Work Order ID 86009

Item Name: Crosstube Low Standard Fwd

DRAWING NO. D212-664-147
REV. B
SHEET 1 OF 4

DRAWING NO. D212-664-147	TITLE CROSSTUBE ASS'Y (205 LOW FWD)	REV. B	DART AEROSPACE LTD ENGINEERING ORDER		D.E.O. NO. D212-664-147-B-1	SHEET NO. SHEET 1 OF 1	SCALE NTS
DRAWN <i>42</i>	CHECKED <i>ASS</i>	MFG. APPR. <i>183</i>	APPROVED <i>WJ</i>		DE APPR. <i>WJ</i>		
DATE 11.07.15	DATE 11.07.20	DATE 11.07.21	DATE 11/07/21		DATE 11.07.21

**D212-664-147/-147B
ASSEMBLY DETAIL**

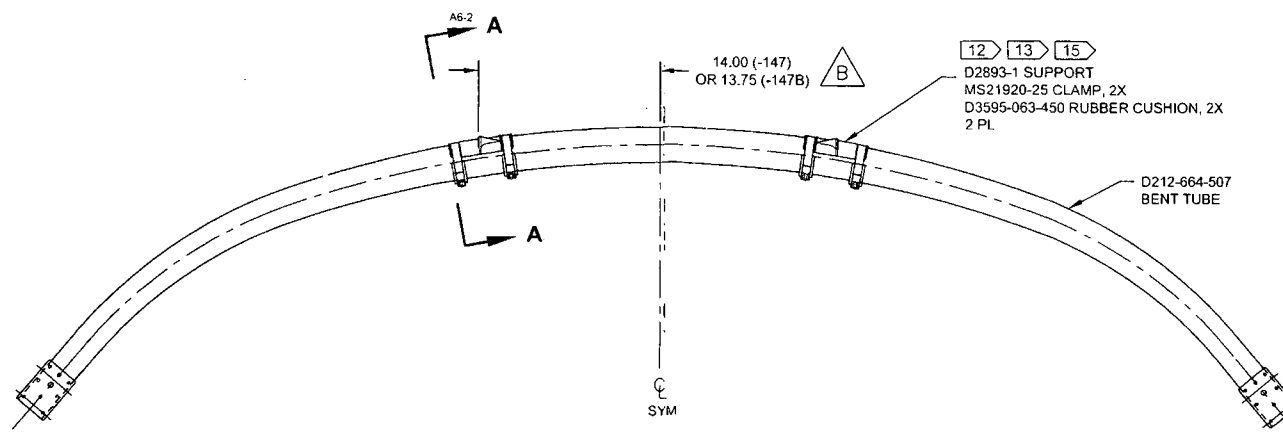
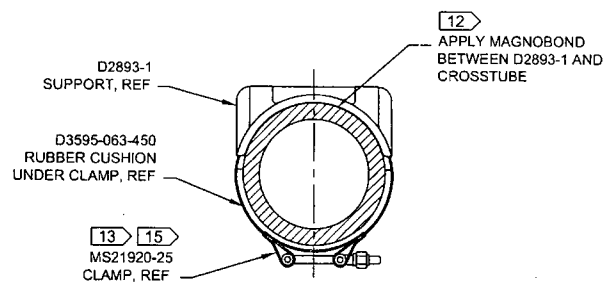
REPLACE MAGNOBOND WITH PROSEAL.

NOTE 12 & 15, SHEET 1 IS AMENDED AS FOLLOWS:

- 12) INSTALL D2893-1 SUPPORT USING 0.03" TO 0.06" THICK LAYER OF MAGNOBOND 6398 TO THE SURFACE OF D2893-1 THAT WILL BE IN CONTACT WITH THE CROSSTUBE PER QSI 015. LET CURE FOR 12 HOURS AFTER INSTALLATION AND PRIOR TO PACKAGING.
- 15) TORQUE CLAMPS 80 TO 100 IN-LB. ENSURE AT LEAST 1.5 THREADS SHOWING IN SAFETY AND THAT NUT HAS NOT BOTTOMED-OUT AFTER TORQUING.

- 12) TO INSTALL D2893-1 SUPPORT: ABRASE MATING SURFACE OF SUPPORT AND CROSSTUBE WITH 180-GRIT SANDPAPER AND REMOVE RESIDUE WITH MEK (OR EQUIVALENT). APPLY A 0.04" TO 0.07" THICK LAYER OF PROSEAL 890 CLASS B-2 (OR AMS-S-8802 CLASS B-2) SEALANT TO MATING SURFACE OF SUPPORT.
- 15) TORQUE CLAMPS 80 TO 100 IN-LB. ENSURE AT LEAST 1.5 THREADS SHOWING IN SAFETY AND THAT NUT HAS NOT BOTTOMED-OUT AFTER TORQUING. **PRIOR TO PACKAGING, RE-CHECK TORQUE ON CLAMPS AFTER PROSEAL 890 SEALANT HAS CURED FOR 72 HOURS.**
